MINERALS PROGRAM INSPECTION REPORT
PHONE: (303) 866-3567

MINE NAME: Diamond Rock Pit	MINE/PROSPECTING ID#: M-2000-047	MINERAL: Gravel	COUNTY: Huerfano
INSPECTION TYPE: Monitoring	INSPECTOR(S): Patrick Lennberg	INSP. DATE: August 26, 2020	INSP. TIME: 10:00
OPERATOR: Diamond B Enterprises, LLC	OPERATOR REPRESENTATIVE: Anthony Blasi	TYPE OF OPERATION: 110c - Construction Limited Impact

Photo 1: Looking south across the topsoil stockpile that will remain after TR approval

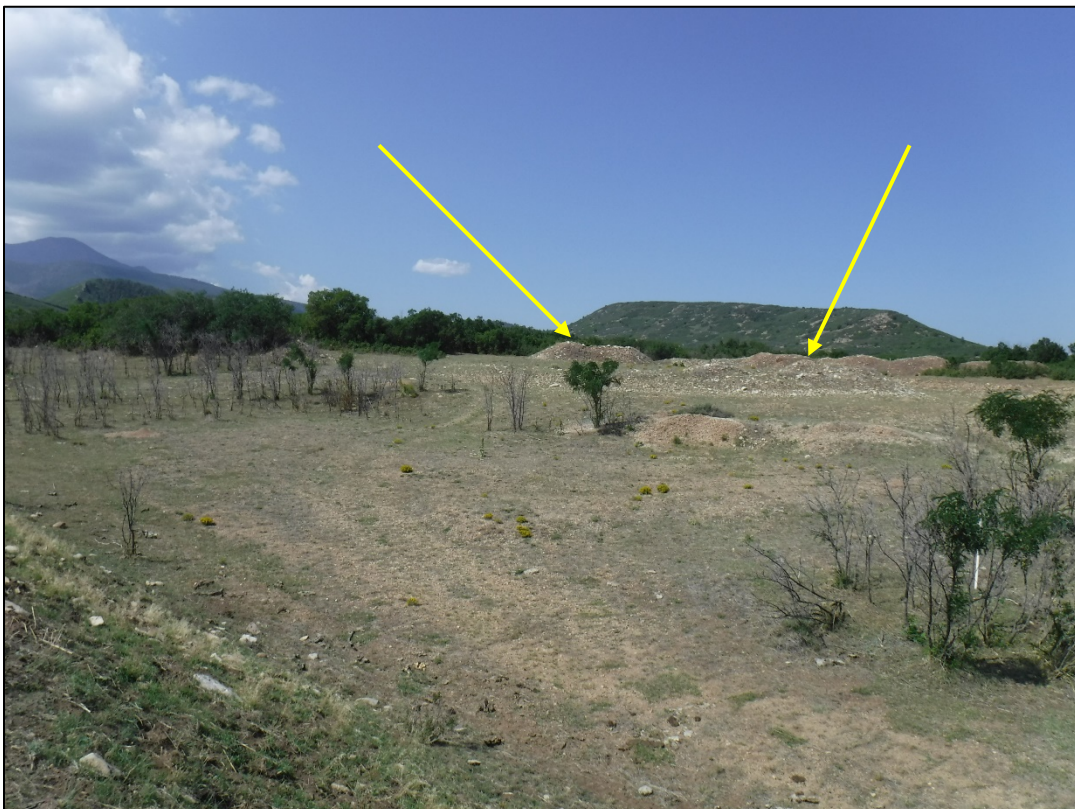
The last activity at the pit is estimated to be May 2006, since that time nothing has occurred at the site including reclamation. Failure to conduct reclamation in a timely manner is being cited as a problem in this report. I was met at the pit by the land owner Bob and the Operator Anthony. During the inspection it was discussed what reclamation needed to occur at the site. It was agreed that the shallow pit area located on the western portion of the disturbed area would be filled in using the adjacent rocky topsoil stockpiles. There are a few minor stockpiles of material that can also be used to fill in the area if needed otherwise the material can be feathered into the surrounding area. Both agreed that minimizing disturbance to the natural vegetation that has volunteered into the pit area was a priority. There is a large stockpile of topsoil material that has a well-established vegetative cover on it that will remain after reclamation is complete. The Operator will need to submit a Technical Revision after reclamation grading and seeding has been completed to update the reclamation plan map to indicate the topsoil stockpile will remain after reclamation is complete. The landowner will have to sign an affidavit agreeing to leave the topsoil stockpile in place.

CORRECTIVE ACTIONS: The operator shall begin reclamation activities within 60 days of the date on the inspection report. The operator shall submit a Technical Revision, with the required \$216 revision fee, to update and clarify the current approved reclamation plan to reflect existing conditions once reclamation has been completed.
